## AMENDMENT 2

- 2 BUNGALOW HOMES ADDED
- N. QUEMOY CT. EXTENDED NORTH
- BUFFER LANDSCAPE ALONG PICADILLY PHASED

GREEN VALLEY RANCH EAST  
PRELIMINARY SITE PLAN #5  
TITLE: KEYMAP  
DATE: March 8, 2023

**O2** TWO-FAMILY HOME (CORNER LOT) 100'-110' X 95'  
NTS

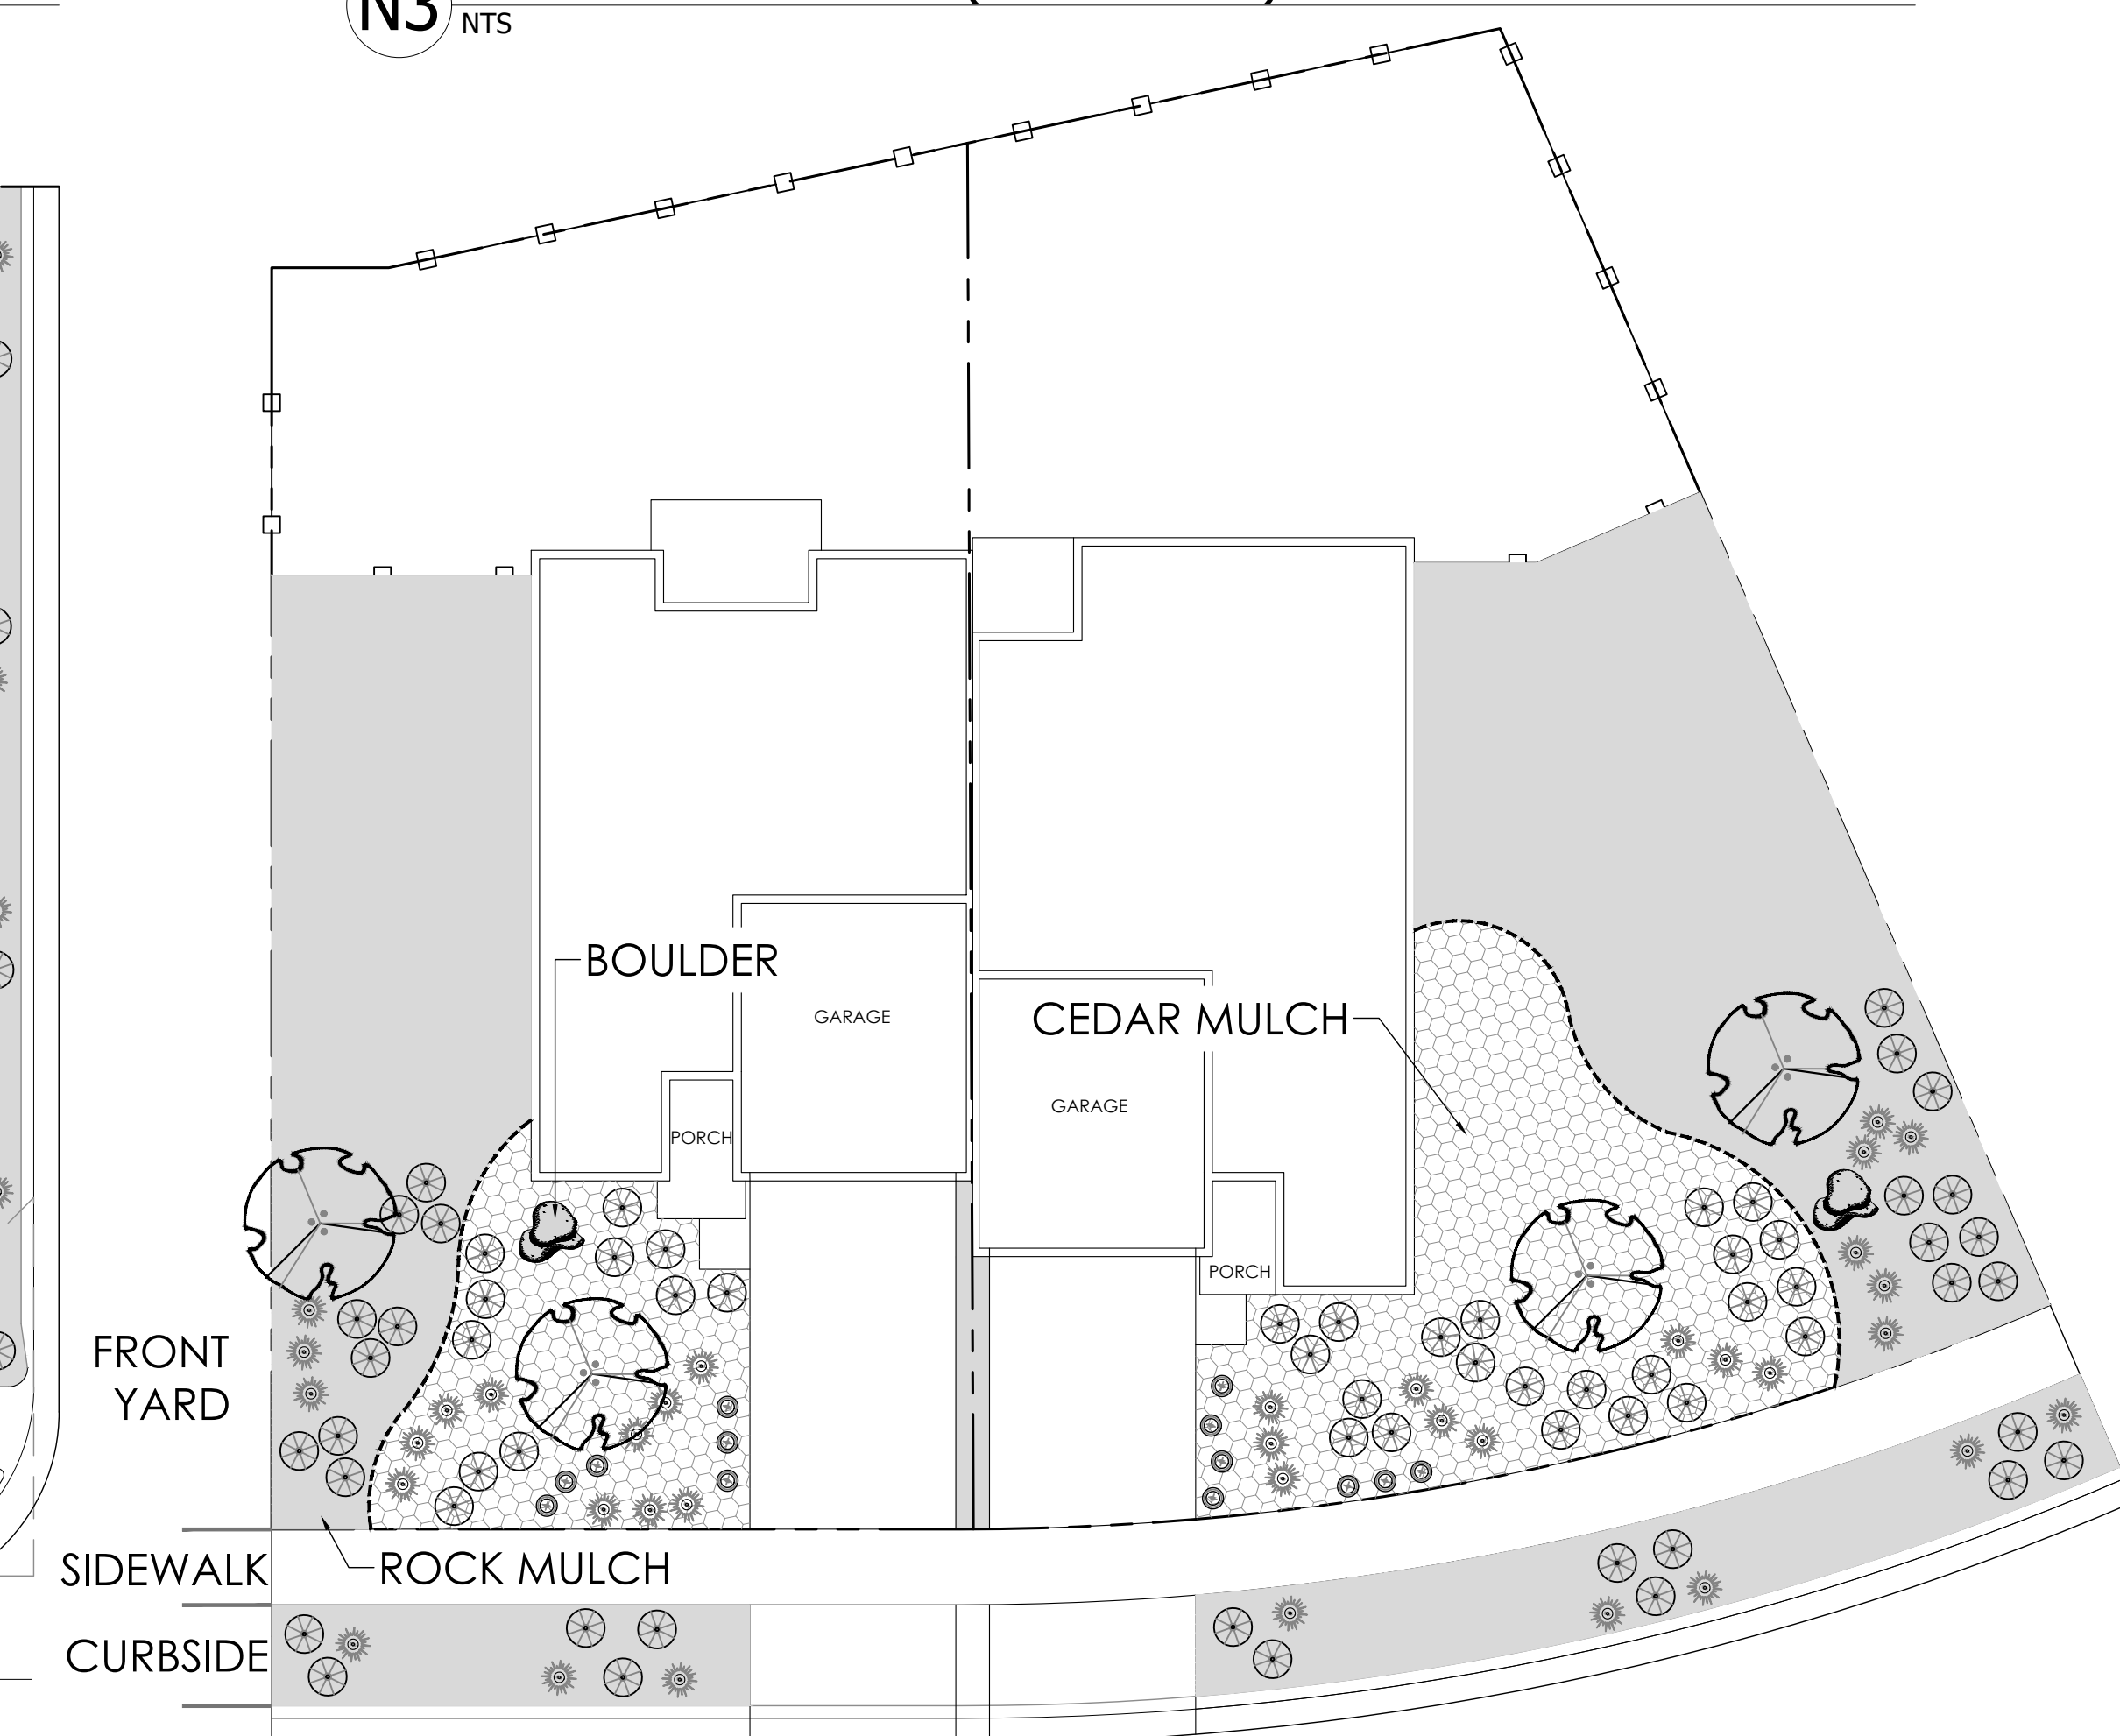
**AMENDMENT 3**  
22 LOTS CHANGED FROM SINGLE FAMILY DETACHED HOMES TO TWO-FAMILY ATTACHED HOMES (DUPLEX). NO CHANGE IN UNIT QUANTITY
